UNITED STATES PATENT AND TRADEMARK OFFICE

APPLICATION NO.	FILING DATE	FIRST NAMED INVENTOR	ATTORNEY DOCKET NO.	CONFIRMATION NO.
10/615,146	07/08/2003	Thomas Kuckelkorn	2678	8229

Office Action Summary

DETAILED ACTION

Figure 4 of US004231353 (KANATANI et al) shows:

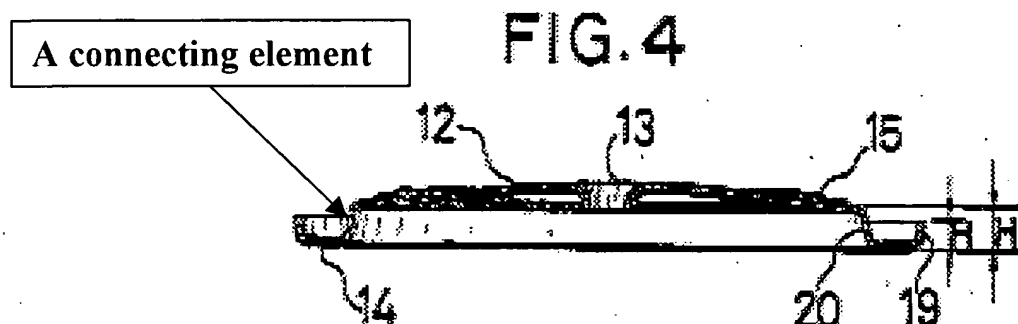
In regard to claims **44 and 45**, **US004231353 (KANATANI et al)** shows (Figure 4) and discloses:

- the interior end (not referenced) of the folding bellows (15) is connected with the glass sleeve tube (9) by a connecting element (20; see annotated figure 4 herein below) and by the glass-metal transitional element (19).

FIG. 4

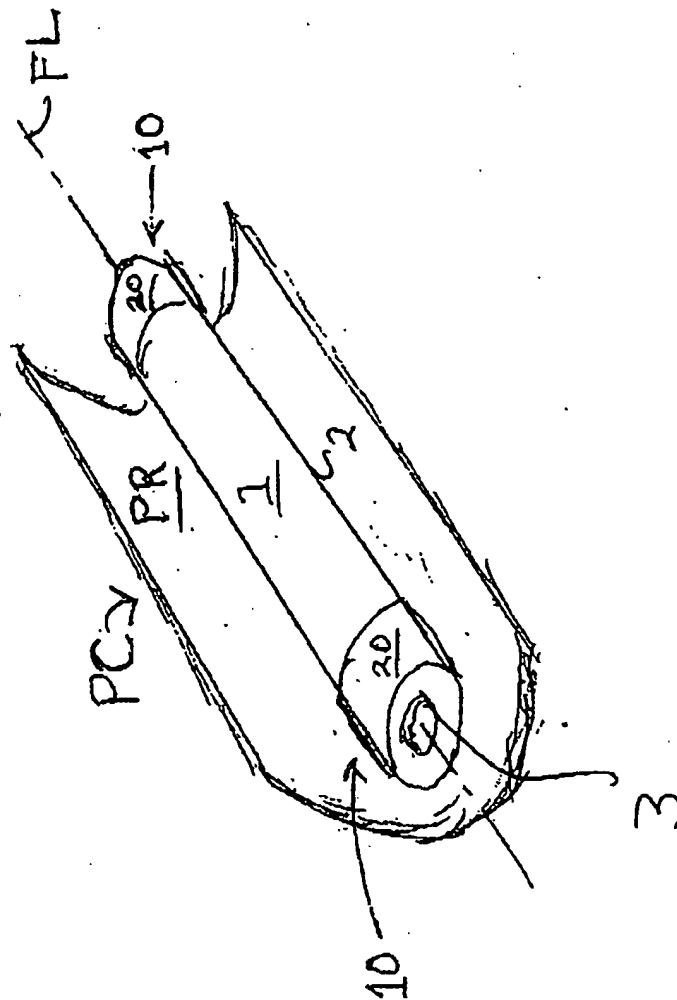
The drawings filed on 06-20-2005 (New Figure 4) are not correctly labeled as “**New Sheet**” pursuant to 37 CFR 1.121(d). Accordingly, replacement drawing sheets in compliance with 37 CFR 1.121(d) are required in reply to this Office action. If the changes are not accepted by the examiner, the applicant will be notified and informed of any required corrective action in the next Office action.

NOT APPROVED
7/5/05
MUST BE
MAKED "NEW"
SHEET
NOT RE-LEGEND
SHEET
